Date: **October 11, 1993**

Subject: **CORRECTING PICTURE SHADING**

Model: **BKM-2085-14/2085-20**
BVM-1310/1315/1910/1915

Figure 5

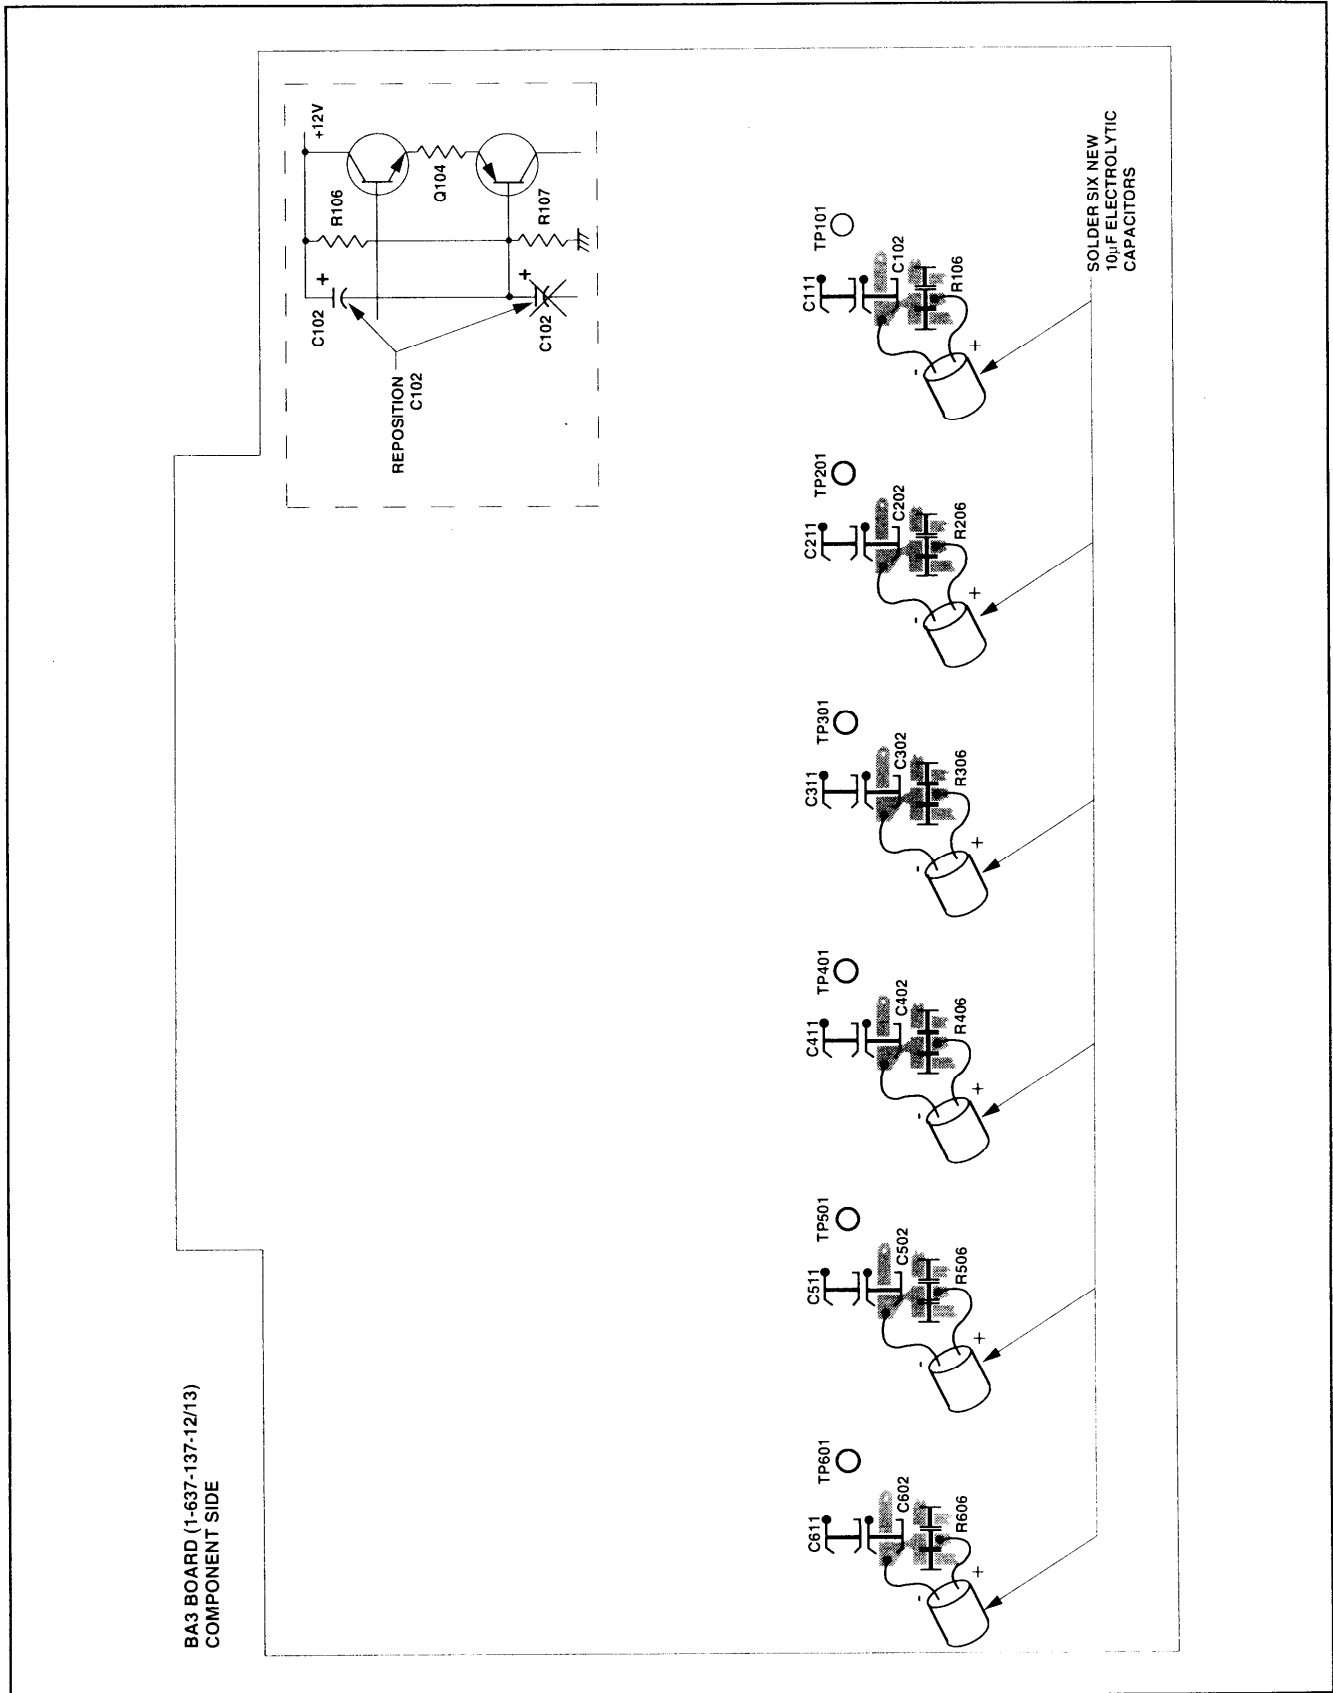
BA3 Board (1-637-137-12/13) Component Side (See Figure 5.)

1. Remove electrolytic chip capacitors C102, 202, 302, 402, 502, and 602.
2. Solder six new 10 μ F electrolytic capacitors at new positions shown in Figure 5.
